PLANNING COMMISSION MEETING  
JANUARY 28, 2025

# Elm Park Planned Unit Development (PUD) & Replat(SUB)

**PC 24 27 PUD 01**

**PC 24 28 SUB 01**

# 1. Setback Reduction

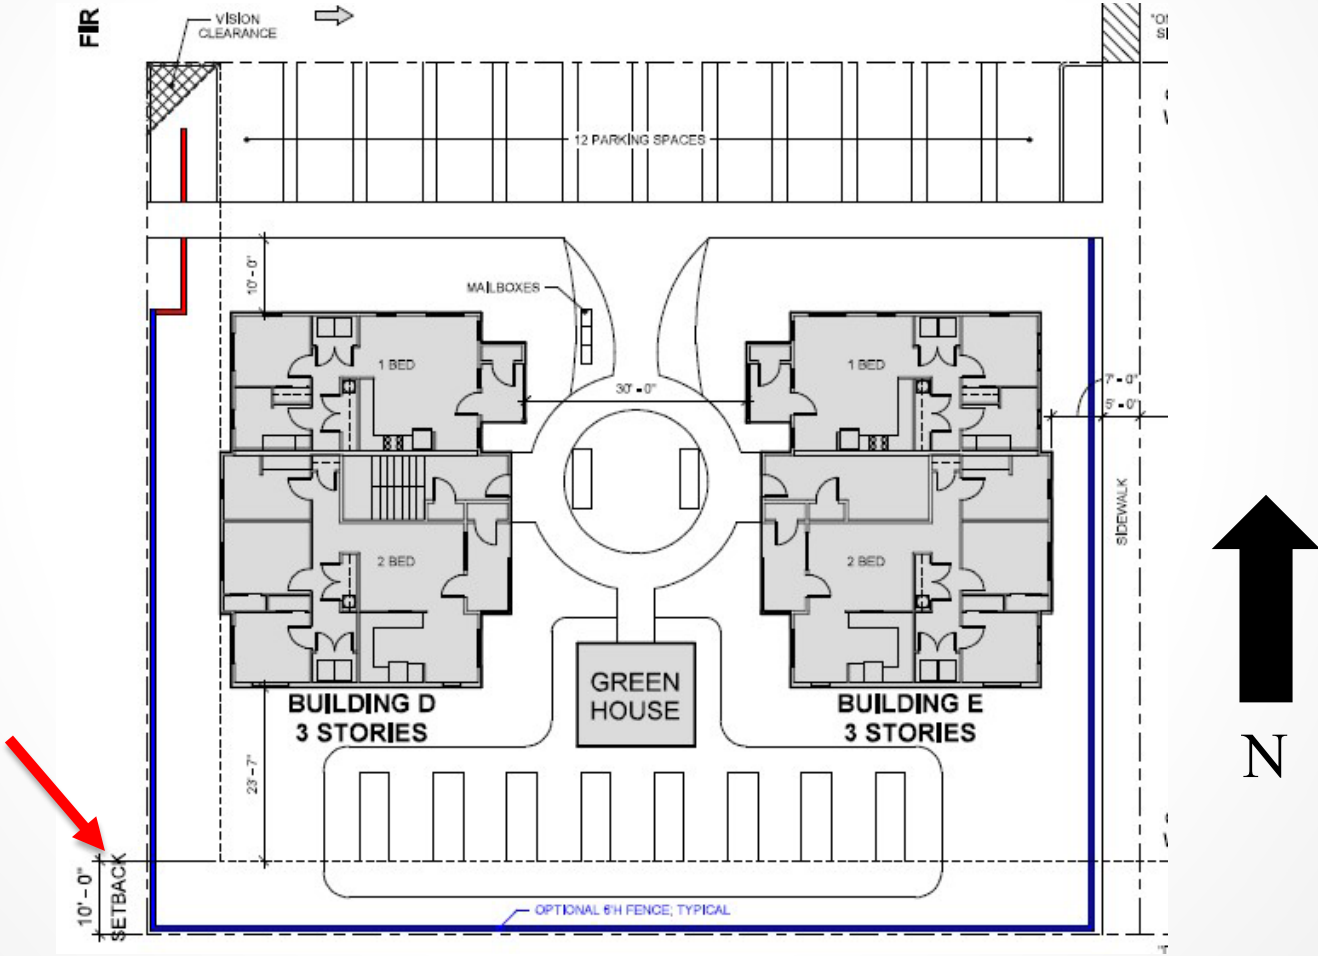
- 1. Reduce front and street-side yards from 20 feet to 10 feet for Lots 1, 2, and 3. This reduction permits an additional 9,000 square feet for dwelling units.**

- Staff recommends approval of Modification # 1

# 3. Wall/Fence Heights

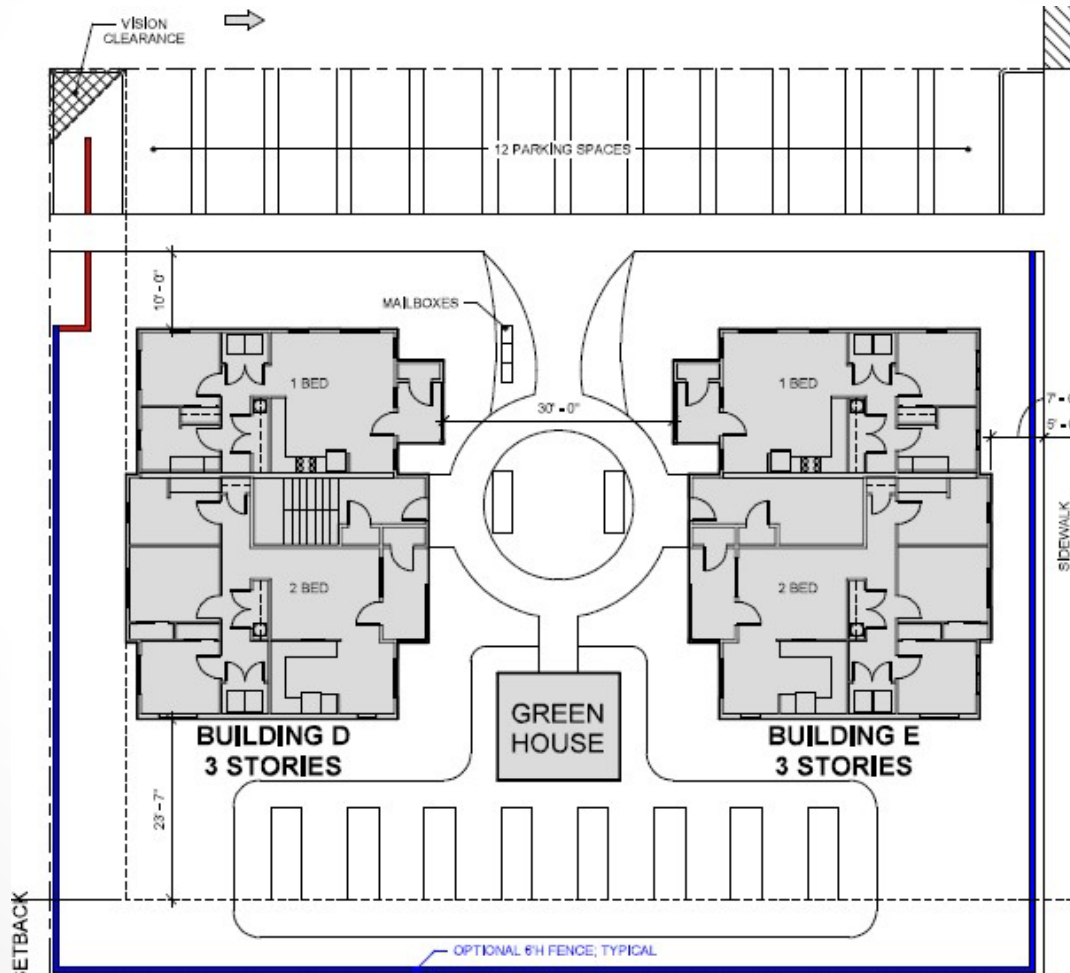
- Lot 2: Front fences are 4 feet tall near the alley and 6-8 feet further back. Other sides are 6-8 feet tall.

- Staff recommend approval of Modification # 3

# 3. Wall/Fence Heights

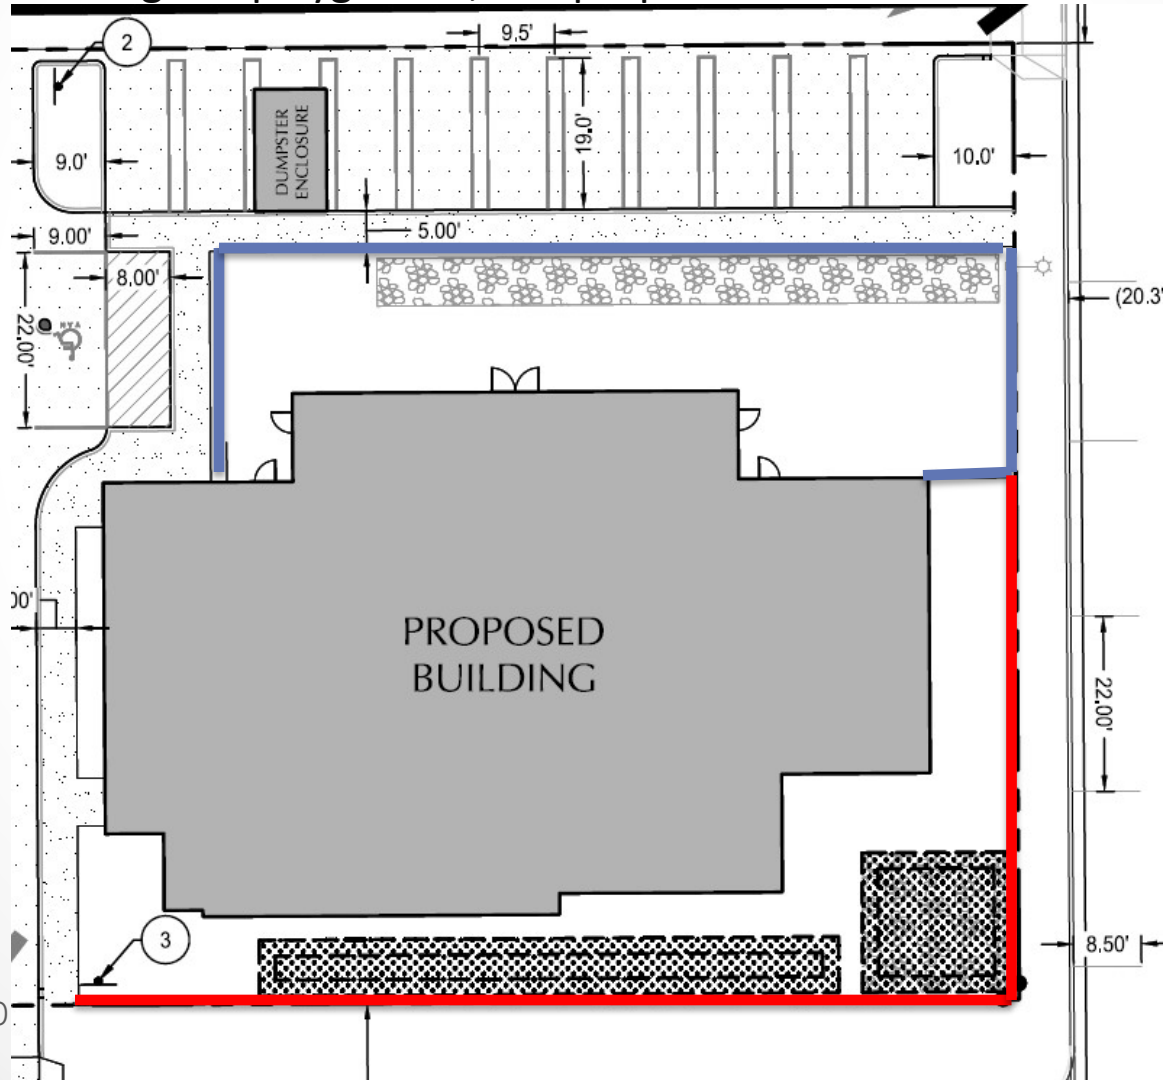
- Lot 3: All front fences along the eastern side would be 4 feet tall. Other than the fence surrounding the playground, it is proposed at 6 feet.

# 4. Open Space Reduction

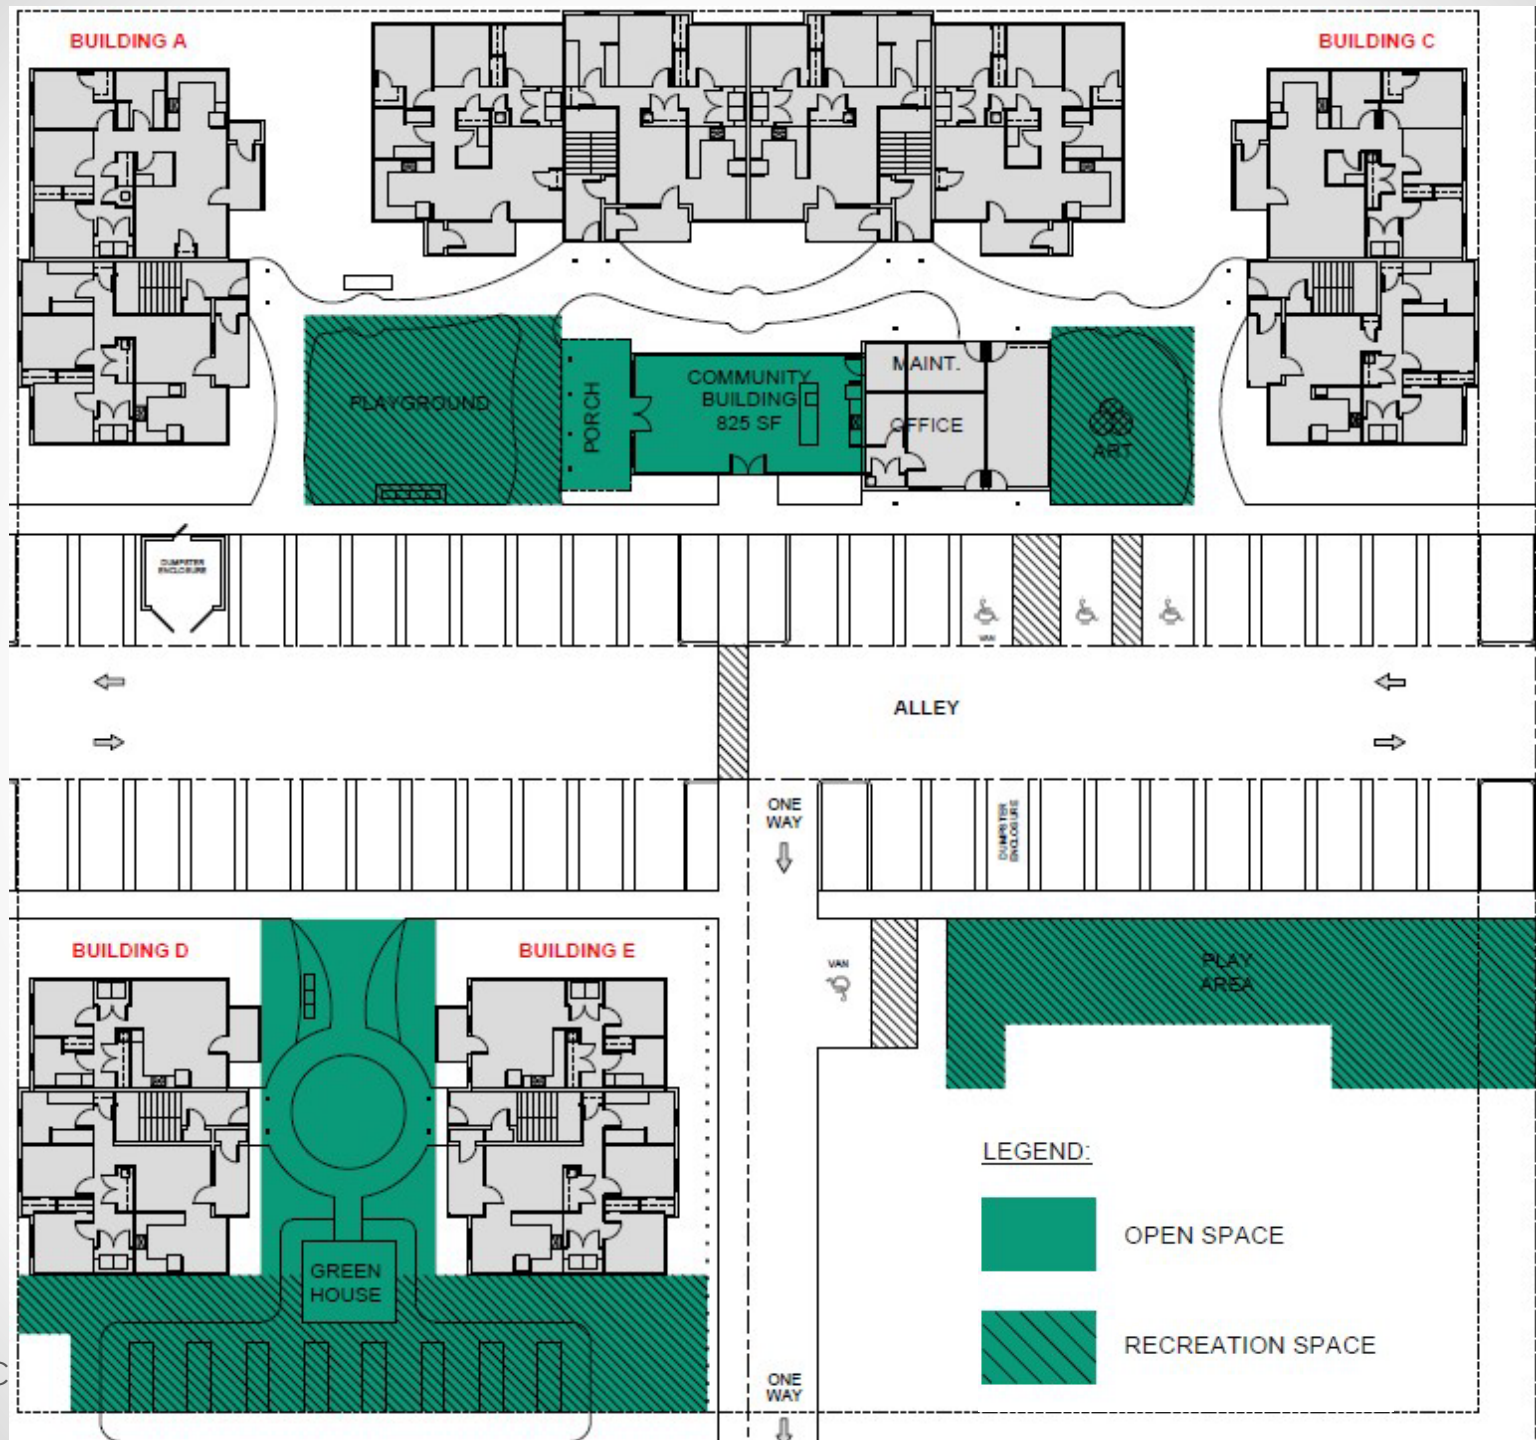
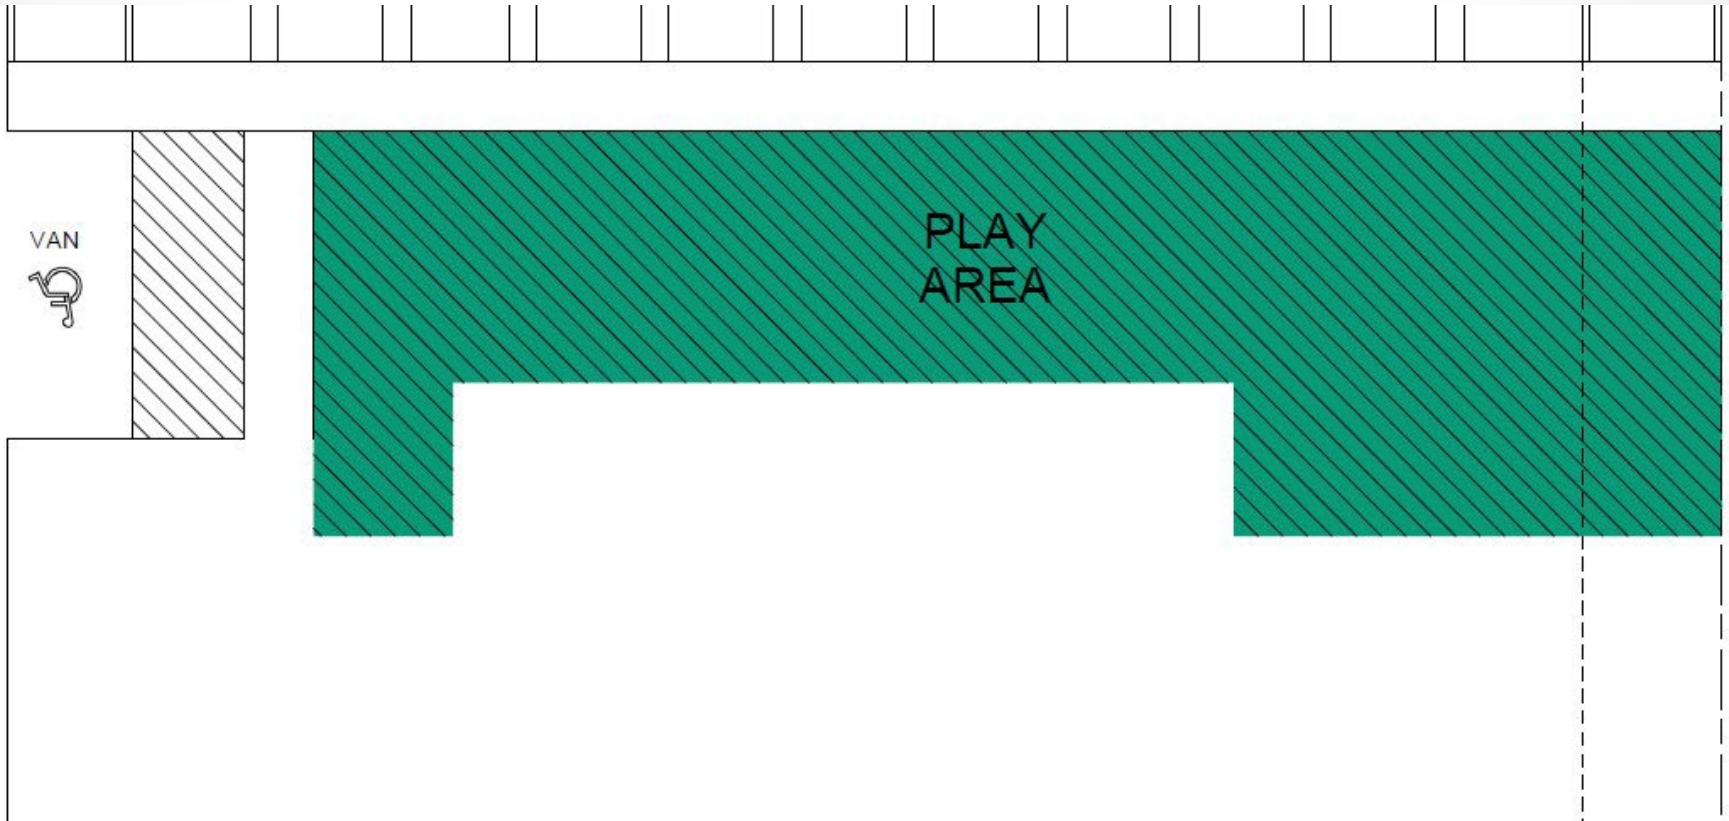
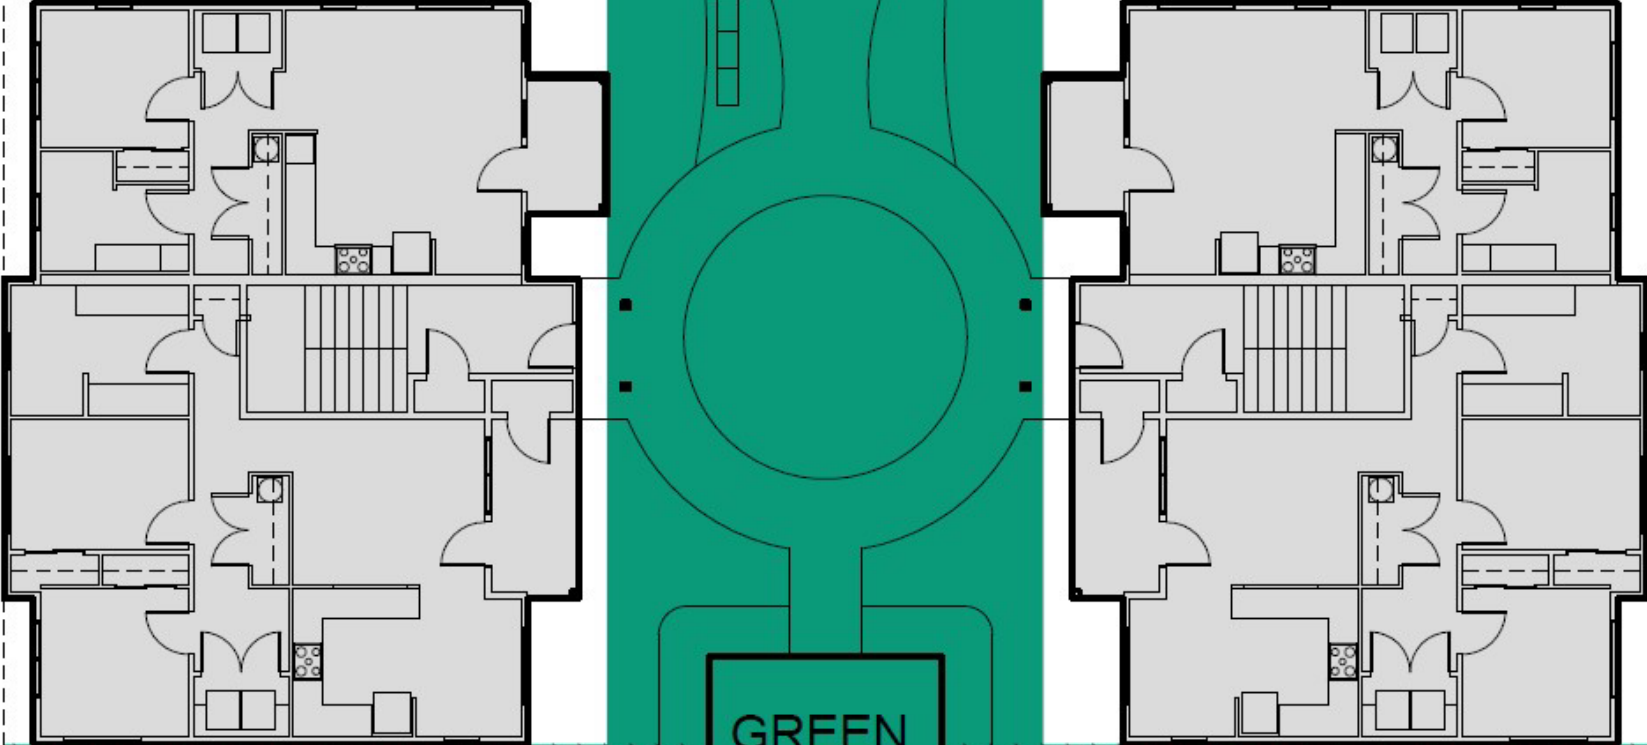
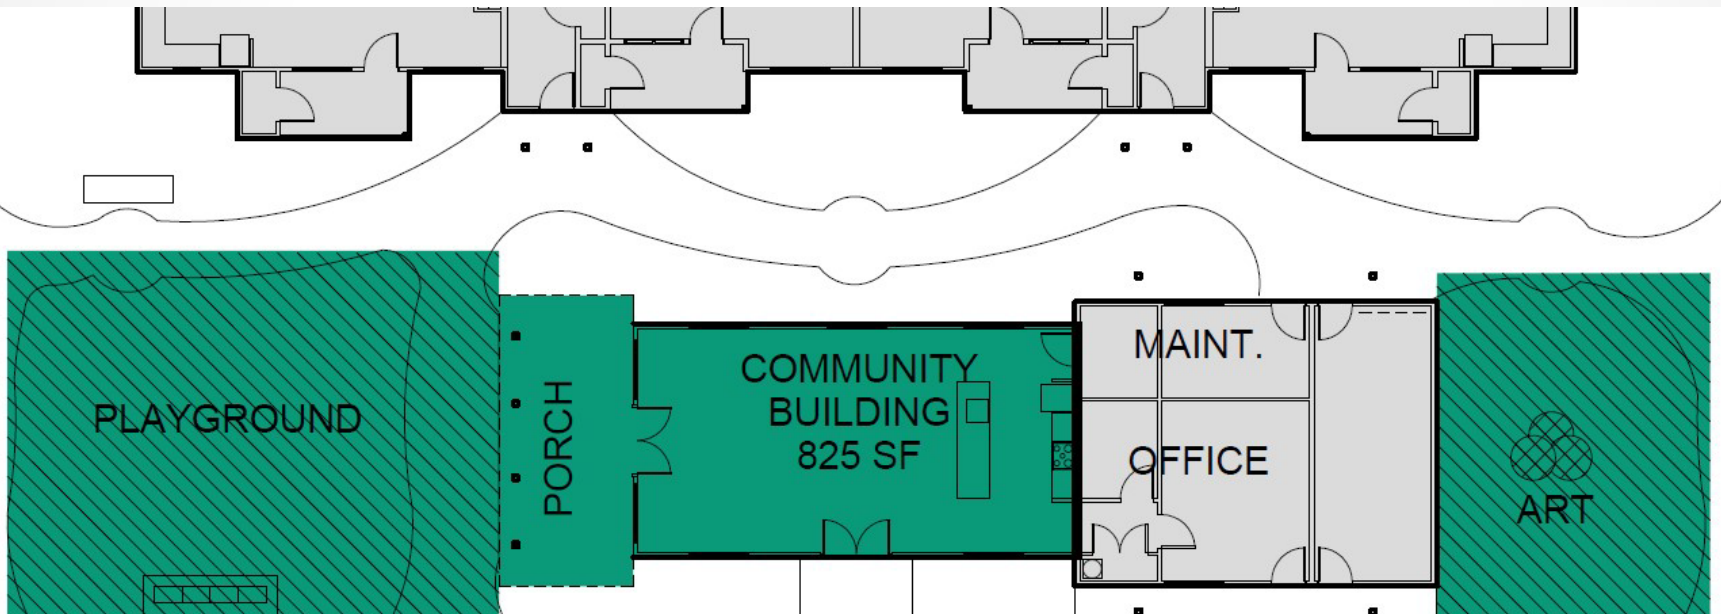
The applicant wants to provide less open space than normally required—about 16% instead of 20%. However, they plan to make up for this by paying a fee in lieu as well as with extra recreation space than is required(25%) like a playground, garden, and community room for residents. Proposing 69% of recreation.

NET DEVELOPMENT AREA = 63,990 SF  
OPEN SPACE = 10,123 SF  
OPEN SPACE / NET DEVELOPMENT AREA = 15.8%  
RECREATION SPACE = 7,010 SF  
RECREATION SPACE / OPEN SPACE = 69.2%

- Staff recommend approval of Modification # 4
